[Docket No. 99-SW-08-AD; Amendment 39-11657; AD 2000-07-03]

Airworthiness Directives; Robinson Helicopter Company Model R44 Helicopters

ACTION: Final rule.

FIGURE 1

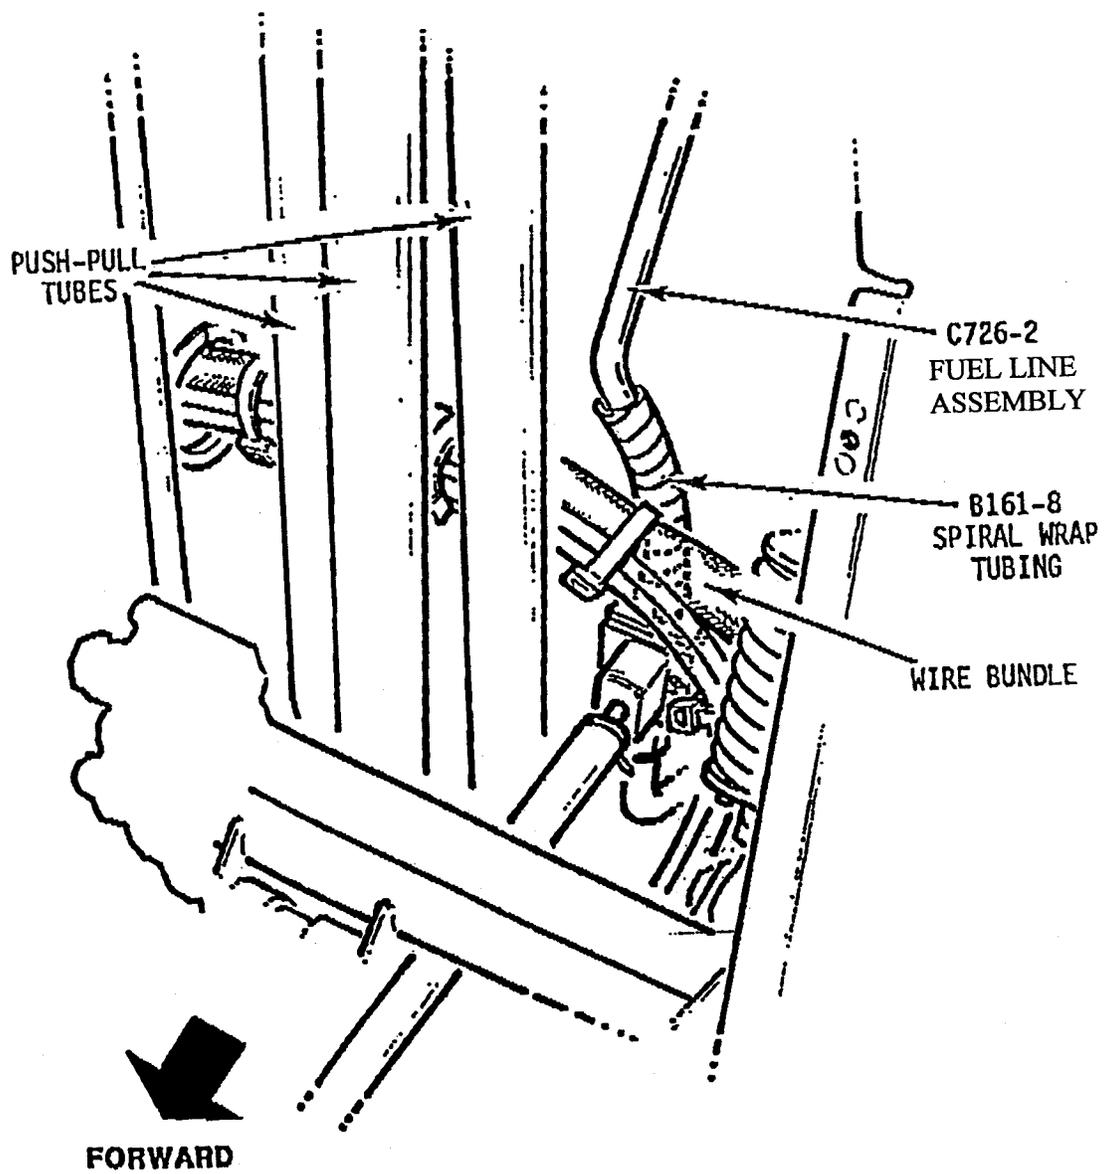
(d) Install a 3-inch section of spiral wrap tubing, P/N B161-8, on the fuel line assembly as shown in Figure 1. Push the spiral wrap tubing down until it is against the fuel line fitting.
